PGP Steering Committee Meeting  
October 6, 2020 2:00pm  
ZOOM

Minutes

**Vermont Sidewalk Expansion Plans - (Part of the 17<sup>th</sup> Street Module)**

# Potrero Gateway Park

Public Works' Option 1 sidewalk plan

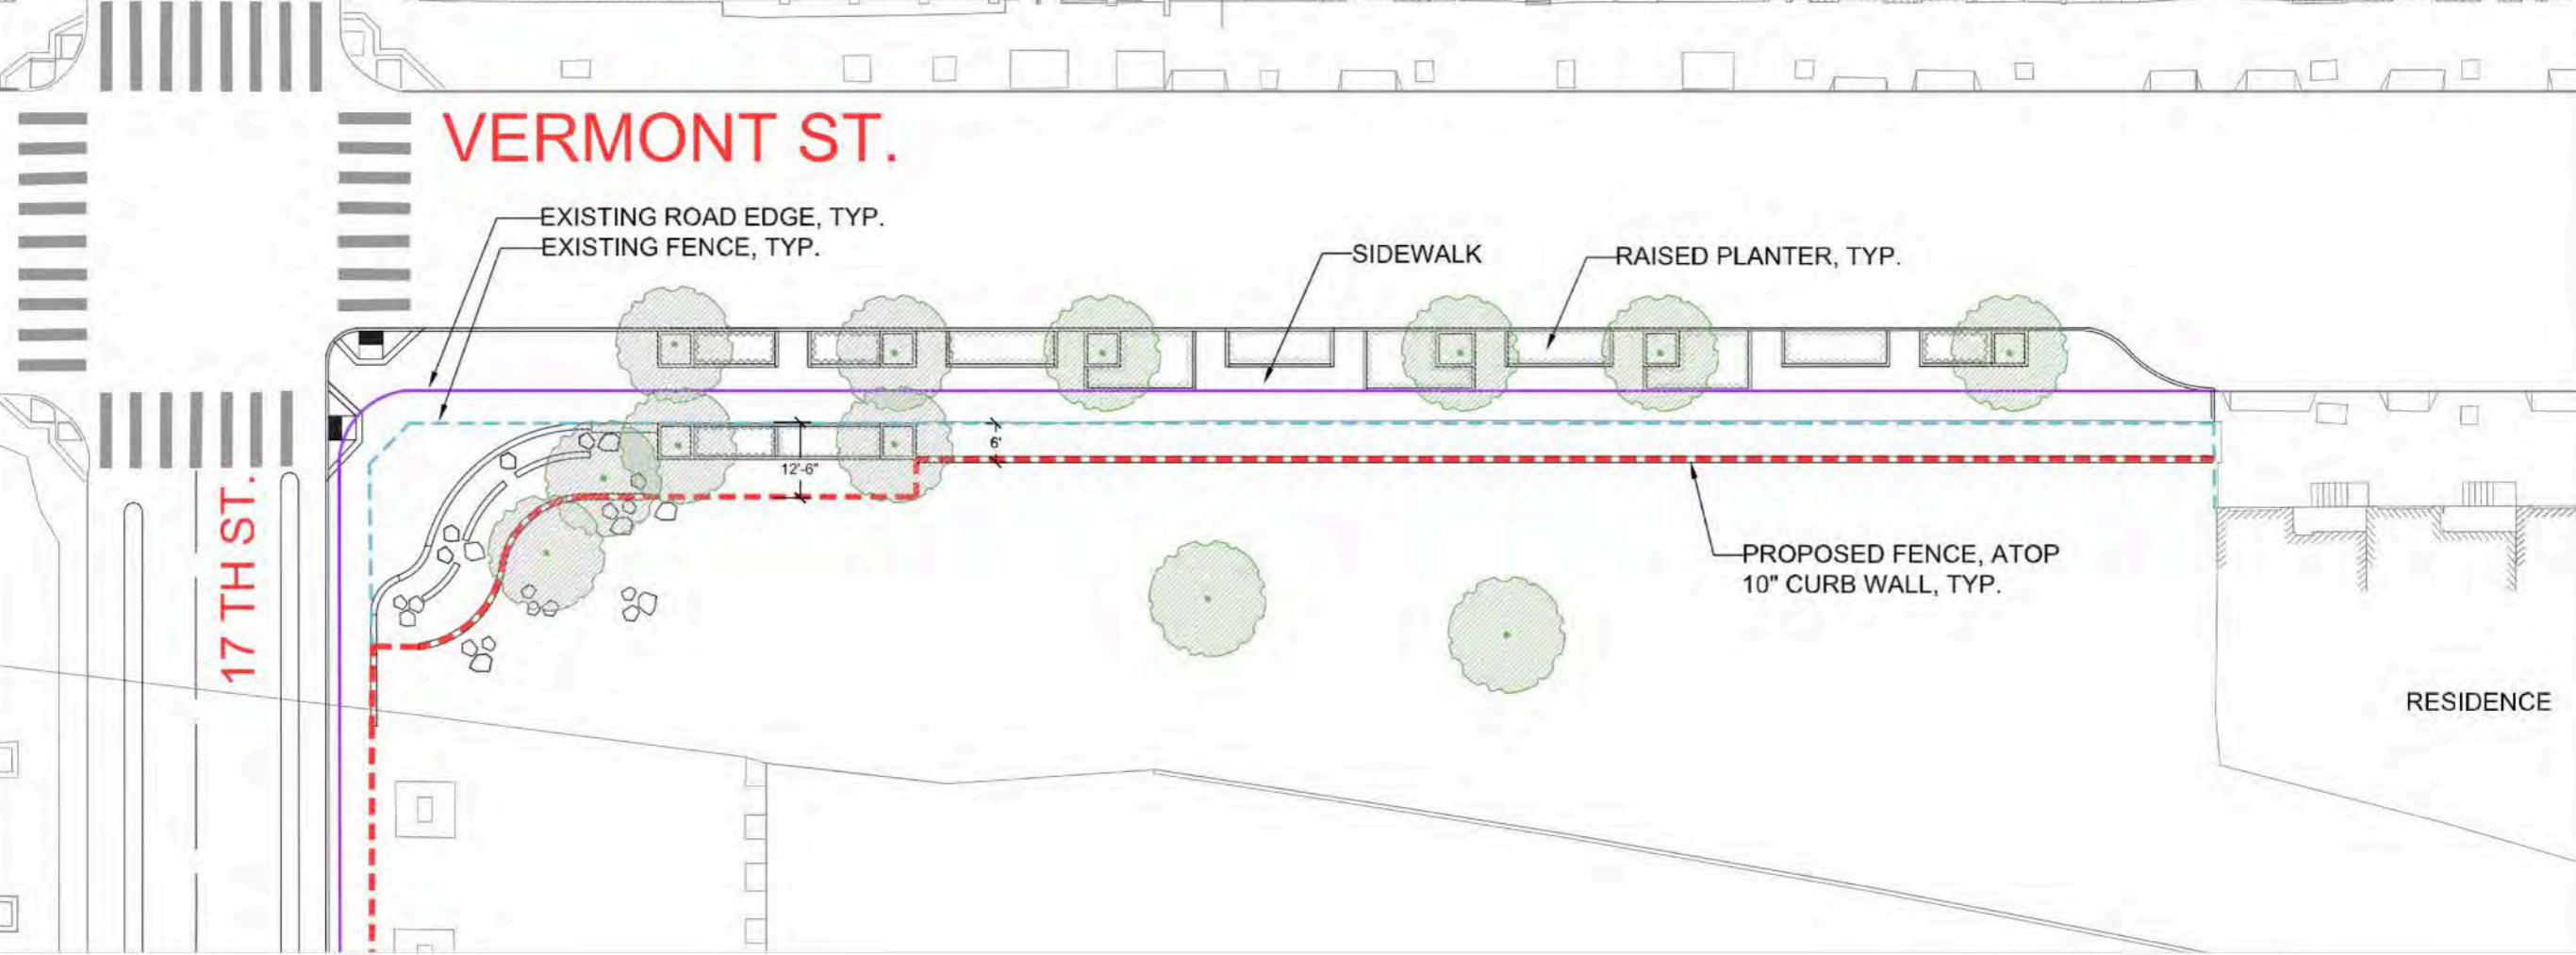
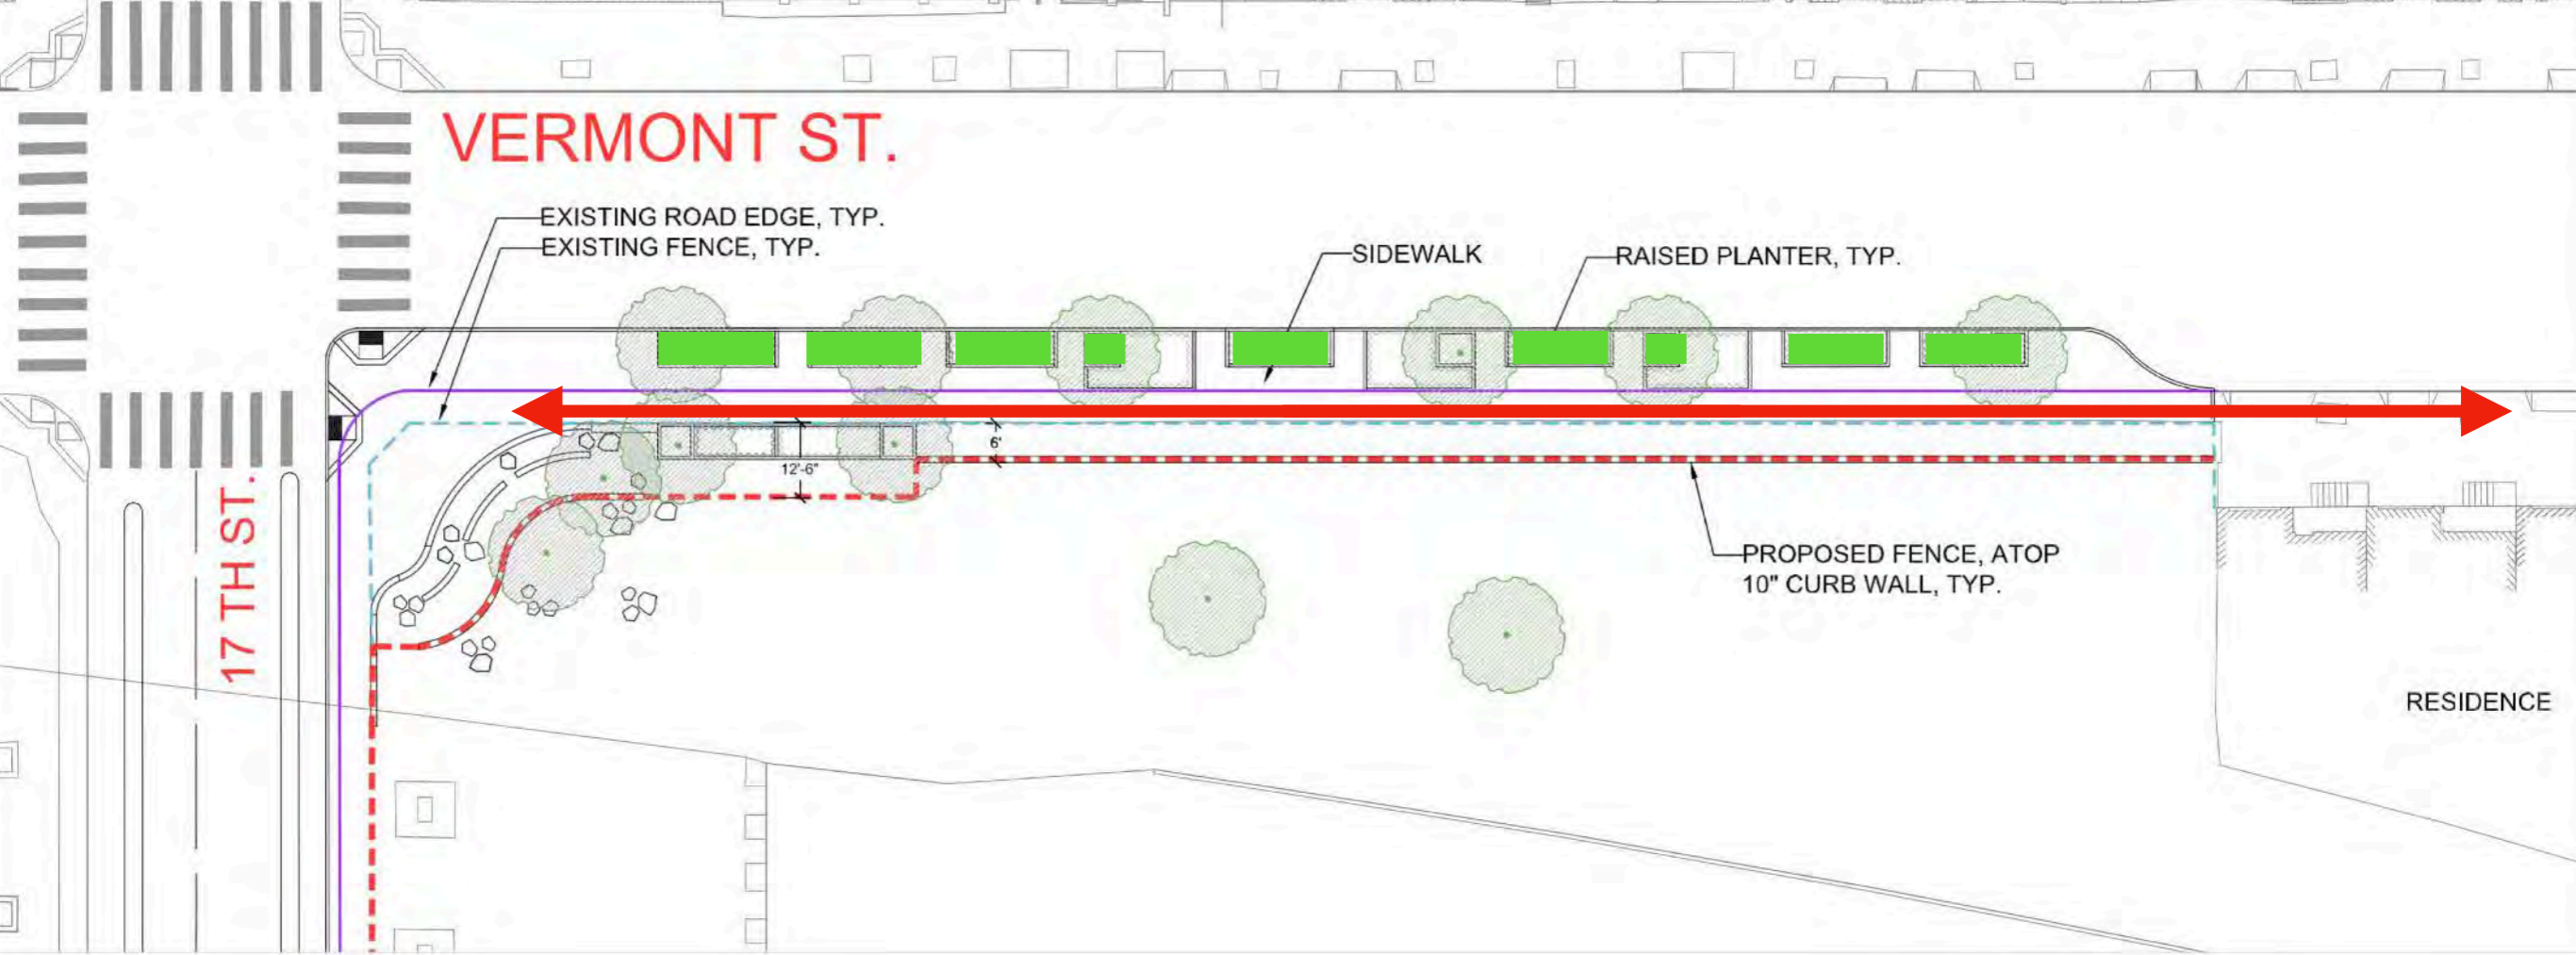
If parking remains, passthroughs are required every 12'.  
and 18-24" of pavers are required adjacent to the curb

Actual greenspace is diminished!
